# **AMENDMENT REPORT**

## **Wellington North Solar Farm**

**February 2021**

**Project Number: 20-483**

Figure 2-1 Updated proposal layout.

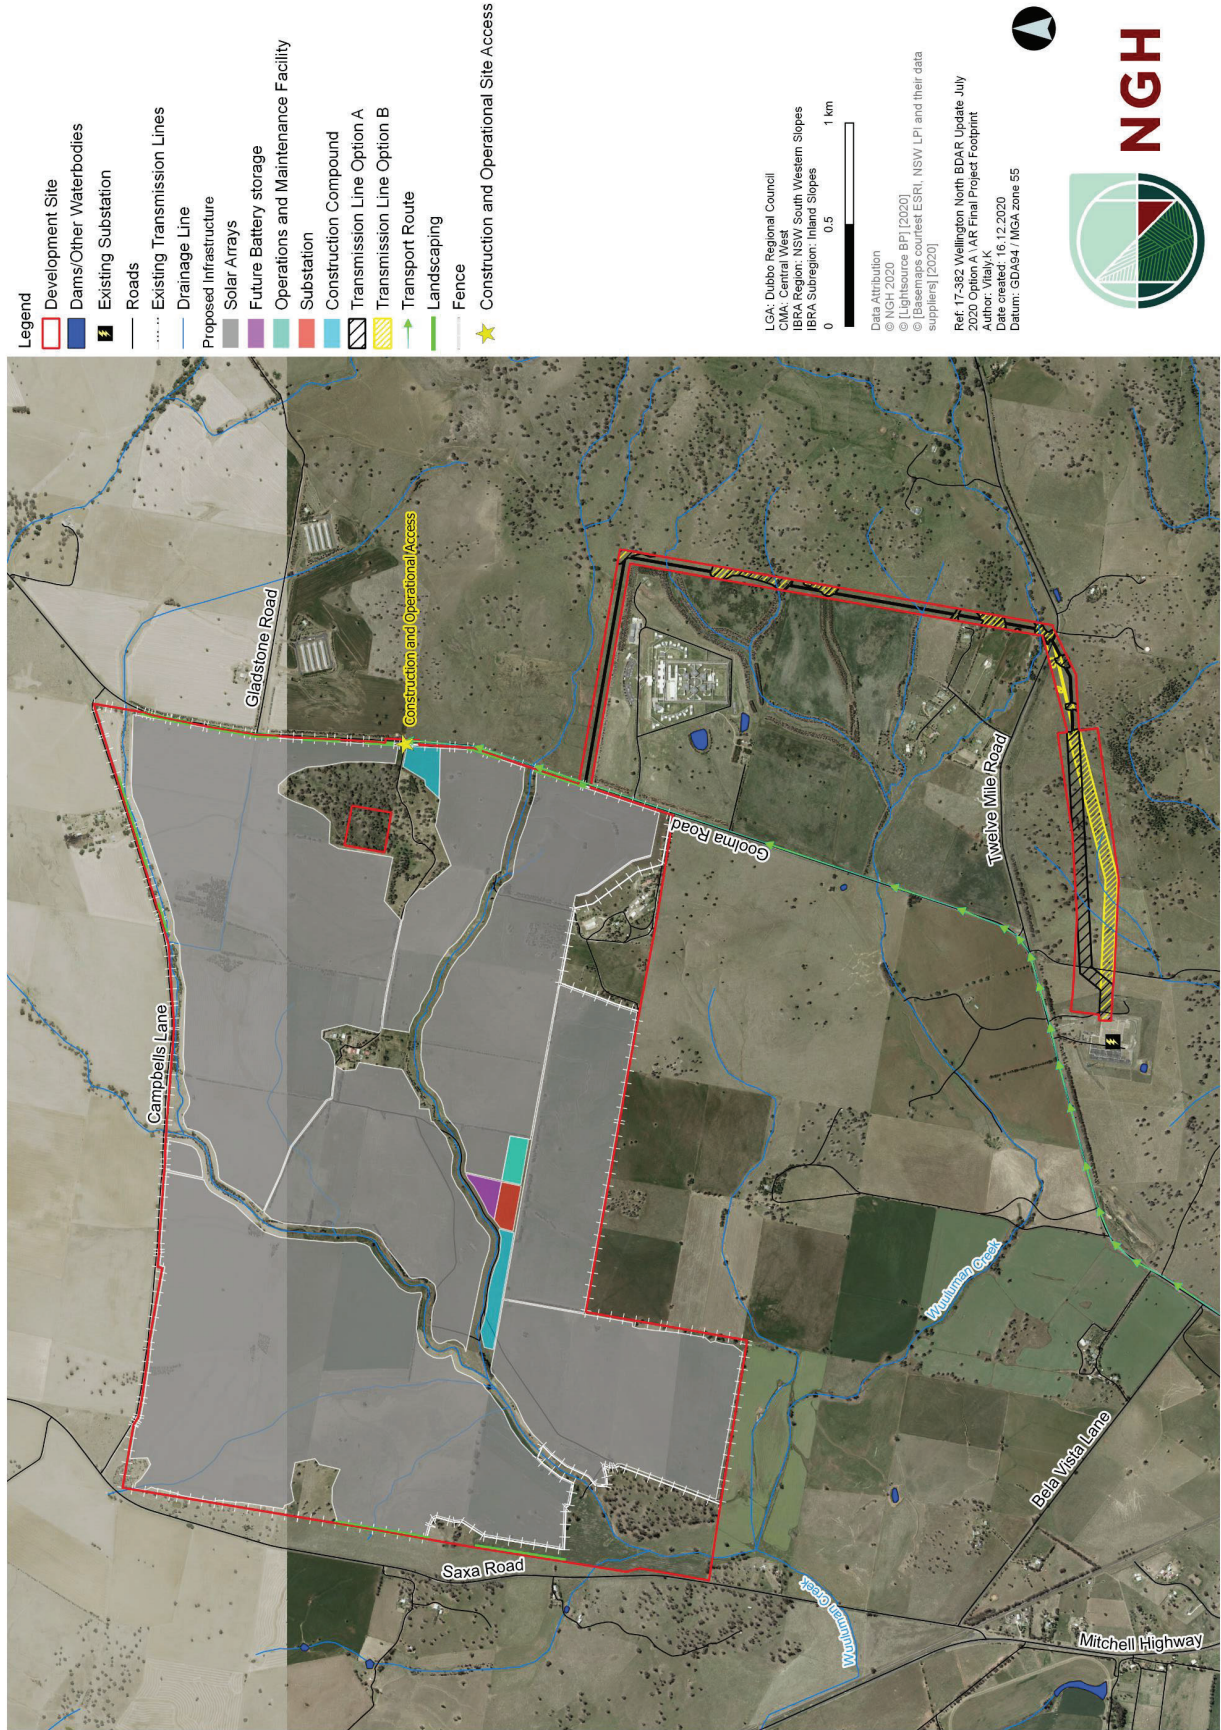
Two options for the development of the transmission line were described in the EIS, these were superseded by the 'new eastern transmission line' as described in the first Amendment Report (NGH, 2019). Lightsource bp has now proposed a change to this transmission line option. The justification for this is provided within Section 2.5 of this report. For this Amendment Report, the updated location for the transmission line relates to the southern portion of the transmission corridor, located within Lot 32 DP622471. The changes can be seen in the updated proposal layout and constraints map provided in Figure 2-1 and Figure 2-2. This portion is located between Twelve Mile Road and the Wellington Substation. The options for this portion include two overhead and/or underground routes for the 330kV transmission line (refer to Option A and Option B in Figure 2-1).

Near TransGrid's Wellington Substation the proposed new eastern transmission line may need to be located underground for a portion of the route, in order to avoid the relocation of existing transmission lines located within the proposed transmission line corridor (refer to Figure 2-1).

All construction and operational site access would now be via Goolma Road at the driveway of the associated landowner (previous Access Point 3), refer to Figure 2-1.

In the EIS there was a construction compound located near the construction site access point on Campbells Lane (Access Point 1). Given the proposed changes to the construction site access point, the Proponent now propose to relocate that construction compound to the entrance of the proposed new site access point on Goolma Road (Access Point 3). The updated location of this construction compound can be seen in the updated proposal layout and constraints map provided in Figure 2-1 and Figure 2-2.

Figure 2-3 Transport Route.

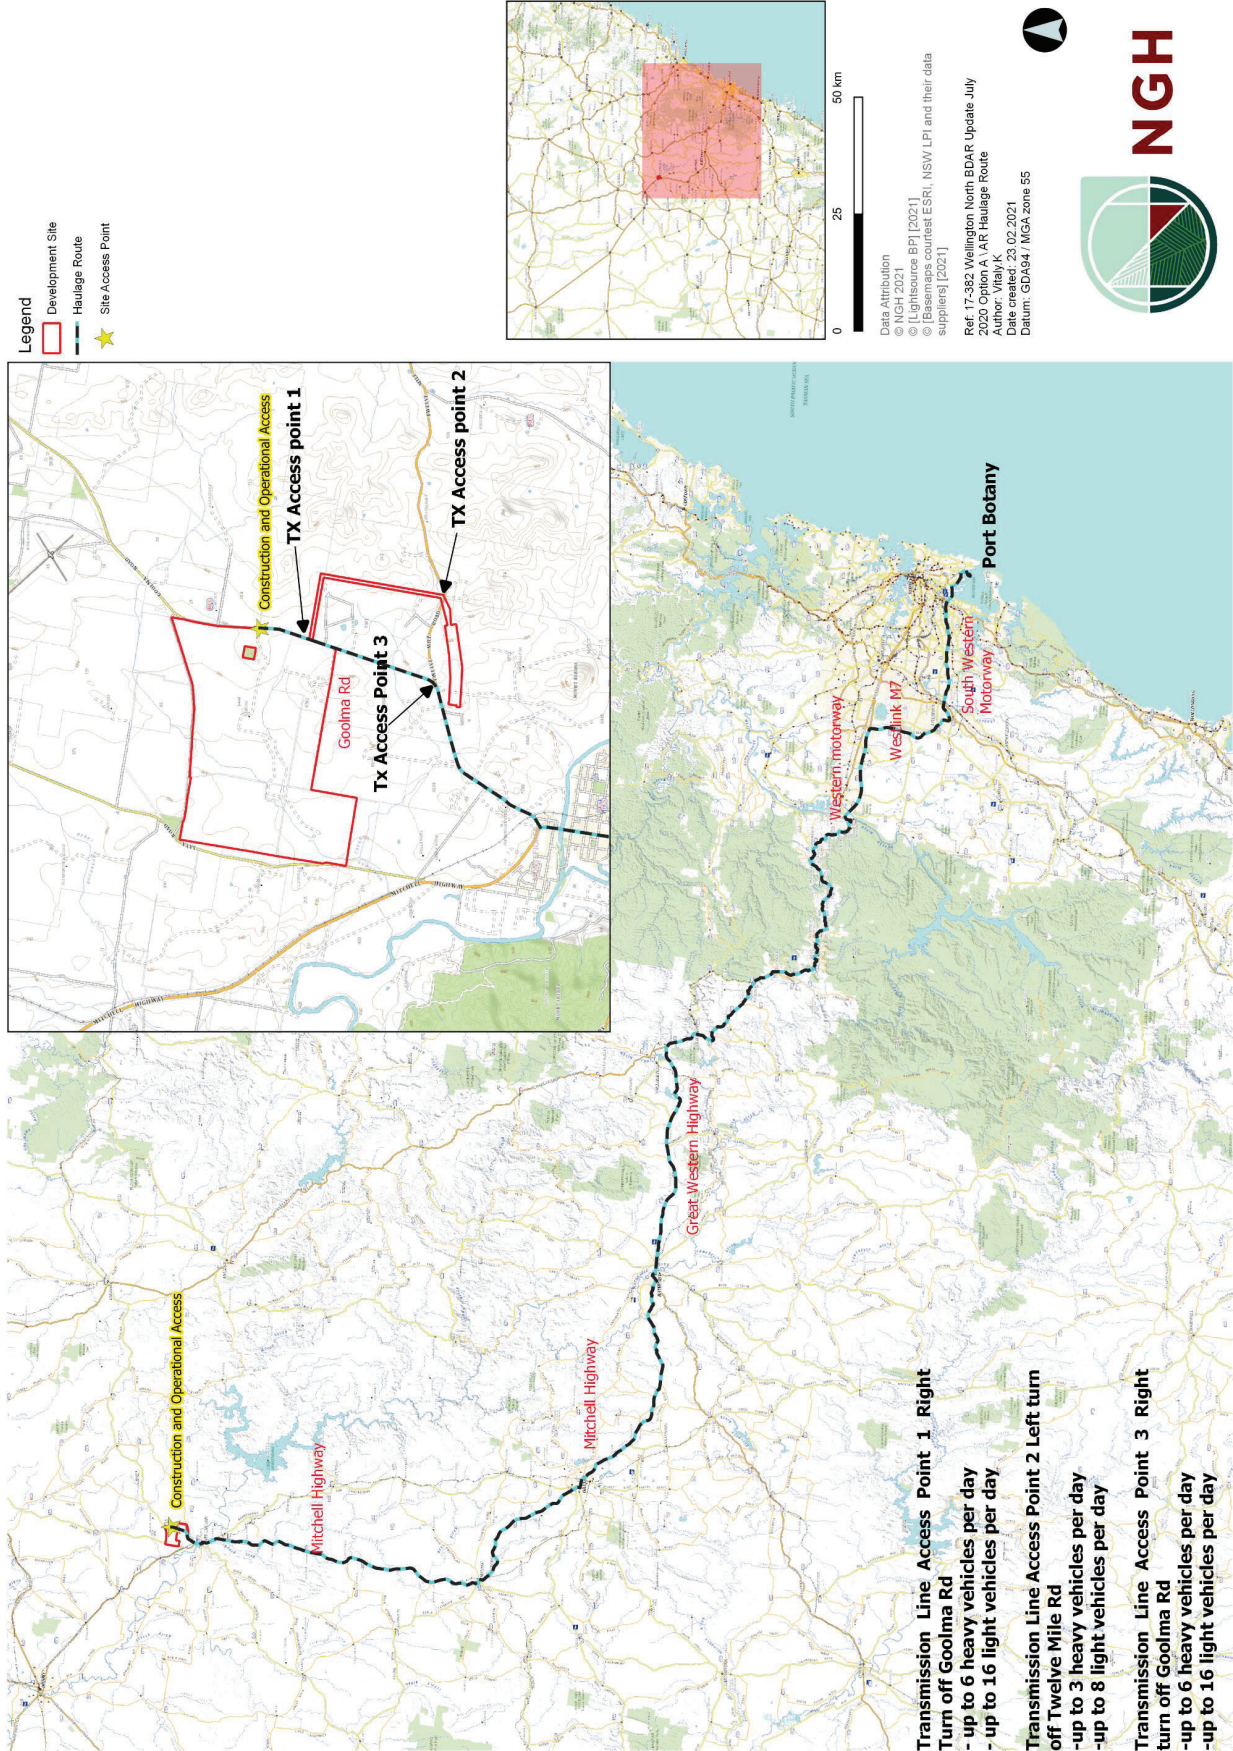
The EIS described the main vehicular access route to the Project site as being from Campbells Lane via Cobbora Road. Lightsource bp now proposes to access the Project site from the south via the Mitchell Highway and Goolma Road. Three site access options were described and assessed in the EIS and previous Amendment Report. The Proponent has now committed that all construction and operational site access would be via a single access point off Goolma Road. These changes can be seen in the updated proposal layout provided in Figure 2-1 and transport route map provided in Figure 2-3 and the justification for this is provided within Section 2.5 this report.

The EIS proposed the main transport route for construction materials would utilise Cobbora Road via the Golden Highway or the Mitchell Highway. Under this proposed amendment, all construction and operational access would be from the south via the Mitchell Highway and Goolma Road at the existing landowners driveway. The impacts of this change have been assessed in the updated *Traffic Impact Assessment* (GHD, 2020). The updated Traffic Impact Assessment is summarised in Section 3.4 and provided in Appendix E.

Figure 3-5 Impacts requiring offsets, not requiring offset and not requiring assessment (south)

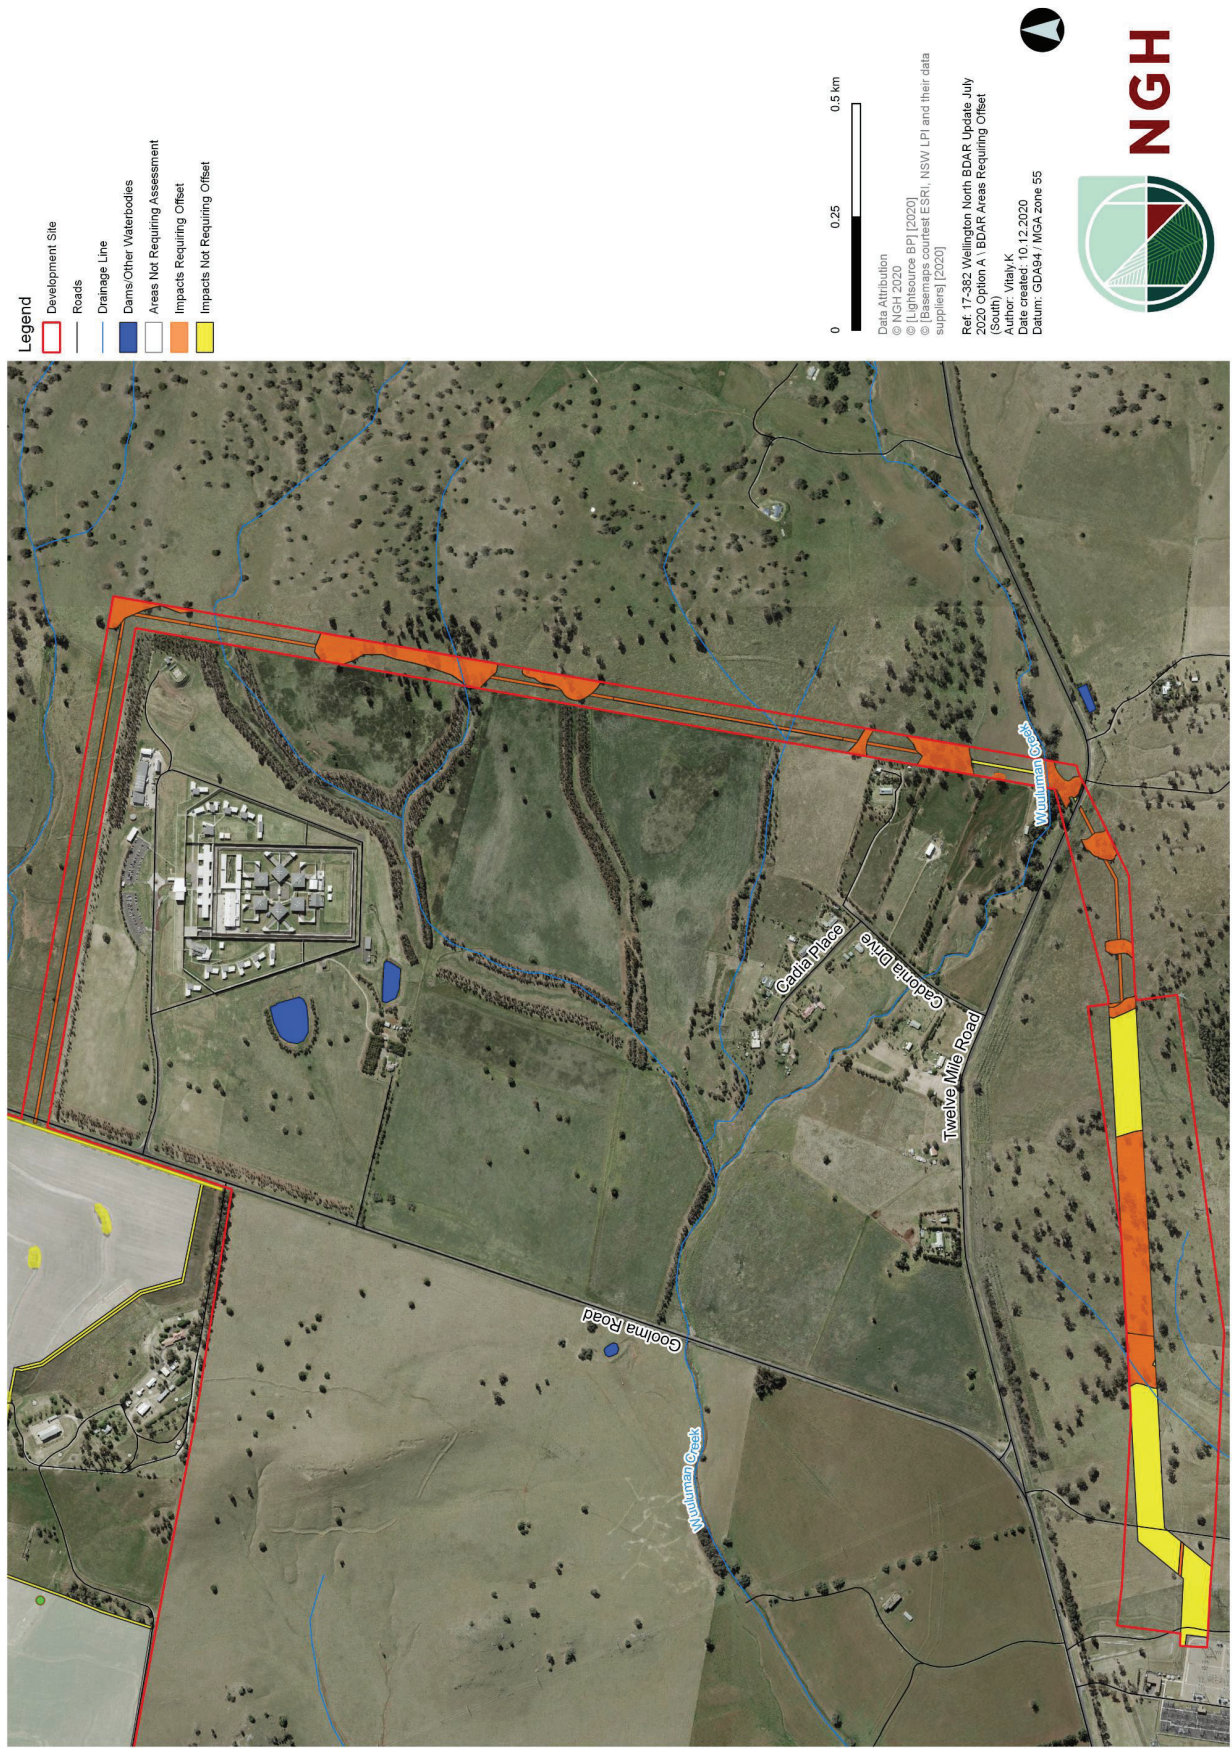
The following updated credit requirement (refer to Table 3-6) is generated for the Project (inclusive of the new eastern transmission line, refer to Figure 3-5), and shows an increase in credits required.

Figure 3-9 AUL(S)/BAL turn treatments (GHD, 2020)

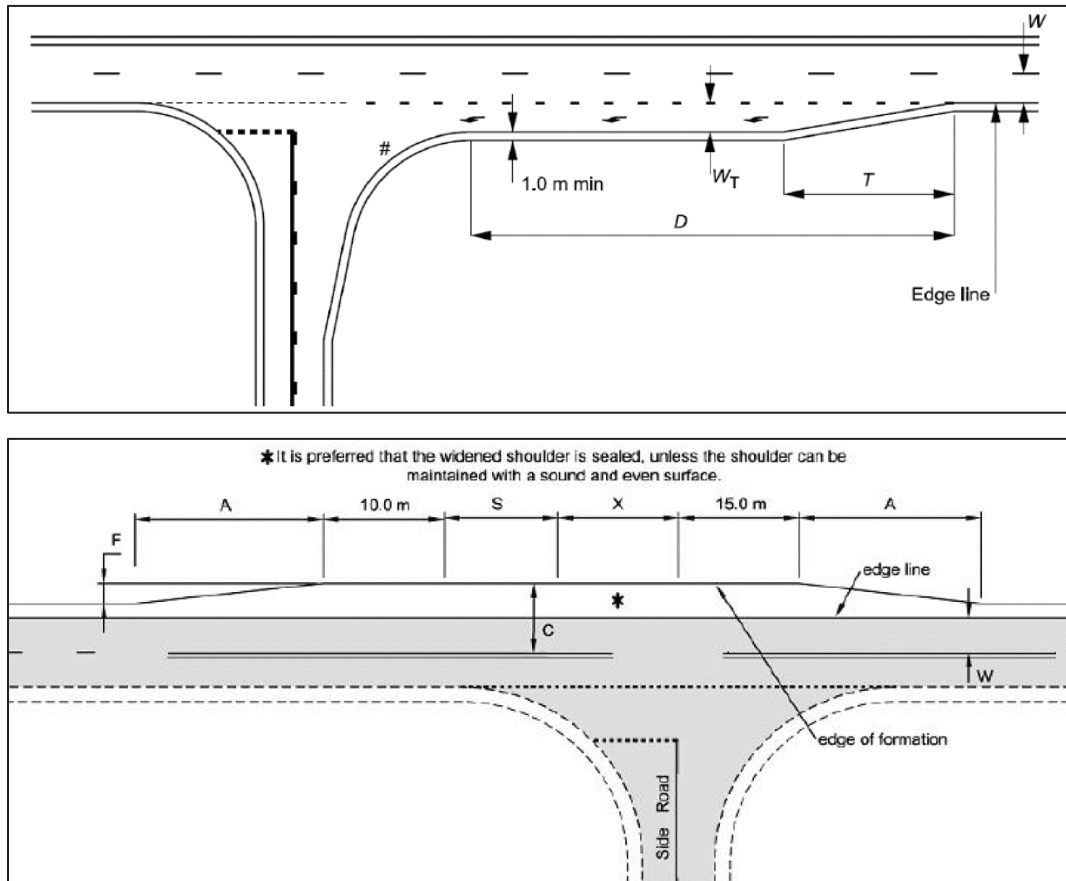
Based on the warrants, it is proposed that consideration could be given to the provision of a short auxiliary left turn lane (AUL(S)) from Goolma Road into the site (Figure 3-9). Although it is anticipated that all vehicles will be travelling to and from the south, incorporating shoulder widening on the eastern verge (i.e. BAR type treatment), would facilitate improved safety for southbound movement as well as facilitating the turn path of larger vehicles exiting the site, if required.

The treatments should be designed to accommodate articulated vehicles up to 19m in length (anticipated typical maximum vehicle length). Larger vehicles will require special permit and traffic management when required.
